Your ref: Docket No. 52-006
Our ref: DCP/NRC1598

**SUBJECT: Transmittal of Westinghouse Responses to Open Items Identified in the AP1000
Draft Safety Evaluation Report**

Westinghouse Non-Proprietary Response to AP1000 Draft Safety Evaluation Report (DSER) Open Items

AP1000 DESIGN CERTIFICATION REVIEW

Figure 3.8.4.3-1- 1 – Temperature Profiles in Structural Module Wall During Initial Part of Thermal Transients

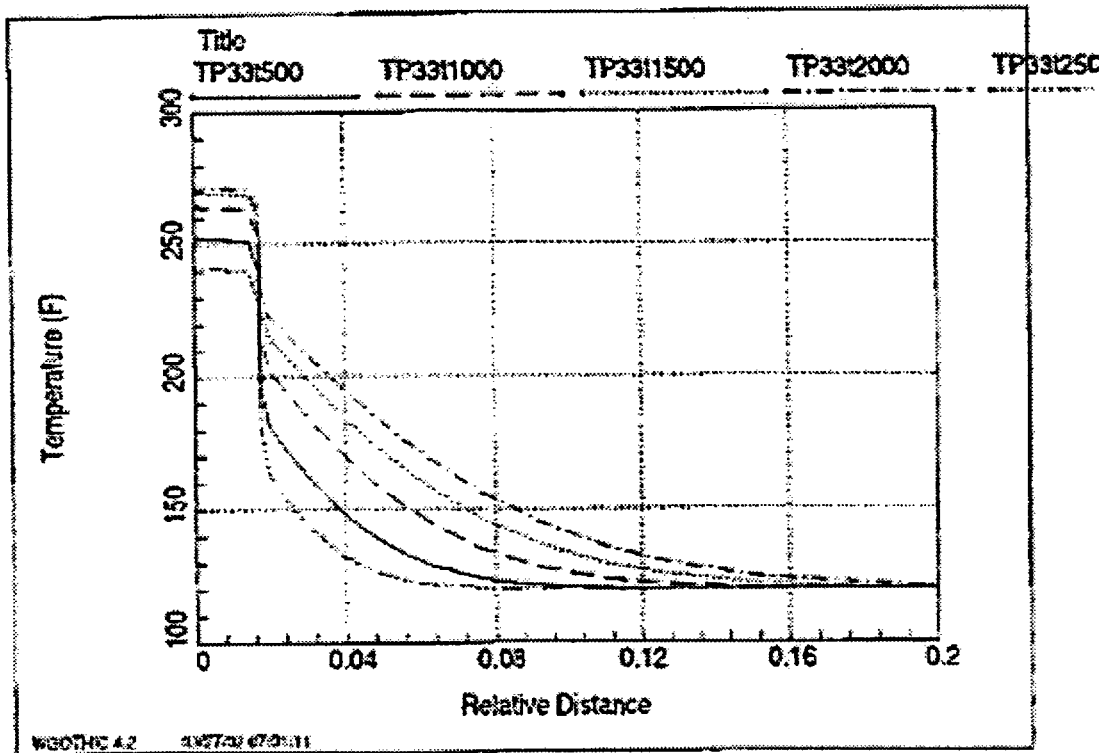
The applicant referenced DCD Tier 2 Figure 3D.5-9 in its response to RAI 220.015; however, it does not appear to have considered the effect of rapid increase in compartment temperature. Based on its review of the selected calculations, the staff could not reach a conclusion that the applicant has adequately addressed the effects of thermal transients on concrete filled steel modules. The analysis approach for the thermal transient inside the IRWST is discussed in Subsection 3.8.3.3 of this report, and has been found to be acceptable. However, for subcompartment locations inside containment (other than the IRWST) and locations outside containment, rapid heat-up of the steel plate of the structural wall modules must be considered in the analysis and design of the structural wall module. The concern is that for a rapid temperature transient, the mismatch in thermal conductivity between the steel faceplate and the concrete could impose significant thermal stresses on the faceplate, studs, and concrete core. This could potentially result in degradation of the faceplate/concrete bond and invalidate the assumption of composite behavior. The applicant needs to evaluate the thermal transients that can occur in the various subcompartments, and demonstrate that no unacceptable degradation would result from differential thermal expansion of the steel and concrete throughout the entire transient. This is Open Item 3.8.4.3-1.

Structural modules are subjected to a rapid temperature transient in the event of a loss of coolant accident (LOCA) or a main steam line break (MSLB). The steel plate of the structural modules heats up most rapidly in the LOCA event. DCD Figure 6.2.1.1-6 shows the containment temperature response for the double ended cold leg break. Figure 3.8.4.3-1-1 shows the temperature distributions in the surface zone of the 30" thick structural module wall during the initial part (2000 seconds) of this LOCA transient. The relative distance shown on this plot is the ratio of the depth to the full thickness of the wall so the 1/2" thick plate is a relative

distance of $1/60 = 0.0167$. These curves show that there are high differential thermal gradients. The initial conditions in this thermal analysis are assumed to be 120°F. Temperatures as high as 270°F are obtained in the first few minutes. The heat up of the plate would be slower but reach similar magnitudes for initial temperatures of the wall of 50°F. The faceplate of a structural module may see differential temperatures ranging from 140°F to 220°F (based on an ambient temperature of 50°F). The concrete heats up more slowly and does not see a significant temperature increase during this early part of the transient. This results in relative thermal expansion of the faceplate, causing shear loads in the shear studs and embedded angles of the structural steel trusses that are welded to the faceplate. It also causes cracking of the concrete once the forces in the steel plate exceed the tensile strength of the concrete wall.
